SAFETY EVALUATION BY THE OFFICE OF NEW REACTORS  
RELATED TO AMENDMENT NO. 1 TO THE COMBINED LICENSE NO. NPF-91  
AND LICENSE NO. NPF-92  
SOUTHERN NUCLEAR OPERATING COMPANY, INC.  
GEORGIA POWER COMPANY  
OGLETHORPE POWER COMPANY  
MUNICIPAL ELECTRIC AUTHORITY OF GEORGIA  
CITY OF DALTON, GEORGIA  
VOGTLE ELECTRIC GENERATING PLANT UNITS 3 AND 4  
DOCKET NOS. 52-025 AND 52-026

**Figure 1. Proposed Revision to UFSAR Figure 3H.5-3**

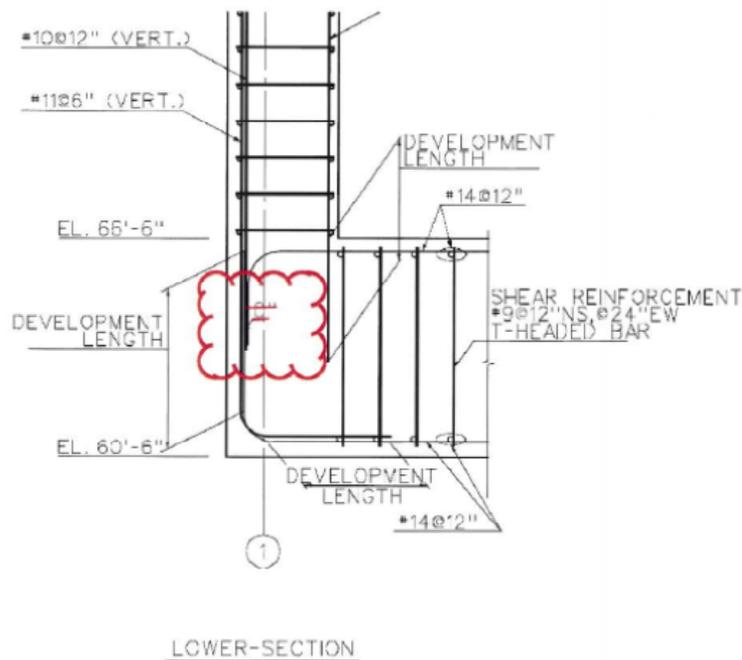
Under the LAR, the licensee also proposed to revise UFSAR Figure 3H.5-3, which is Tier 2\* information, by removing the dimension, labelled as 0-inches, in the portion of the figure showing the junction of the basemat and exterior nuclear island wall (along Column Line 1). The 0-inch dimension indicates that vertical reinforcement at this location will be in the same vertical plane (Figure 1 below). The LAR states that removing the dimension does not change the design of the basemat or conformance with the ACI 349-01 code.

In LAR Section 3, the licensee proposed to revise UFSAR Figure 3H.5-3 to remove the dimension labeled 0-inches in the portion of the figure showing the basemat below the wall. This section also states that the particular dimension is being removed for the Vogtle design, as the hook-end and vertical wall reinforcement will not be aligned in the same vertical plane. The licensee concluded that the design revision does not change the design of the basemat longitudinal or shear reinforcement.

The staff performed a review of the proposed change to UFSAR Figure 3H.5-3, and it concludes that the removal of the dimension labeled as 0-inches does not reduce the capacity of the basemat to exterior wall joint or conflict with ACI 349 code provisions. Accordingly, the staff concludes that the design revision has no impact on the design of the basemat.

6. The removal of the dimension labeled as 0-inches in Tier 2\* Figure 3H.5-3 does not affect the ability of the critical section joint to perform its function under design-basis demands or conflict with ACI 349-01 code provisions. Accordingly, the staff concludes the design revision has no impact on the design of the basemat.
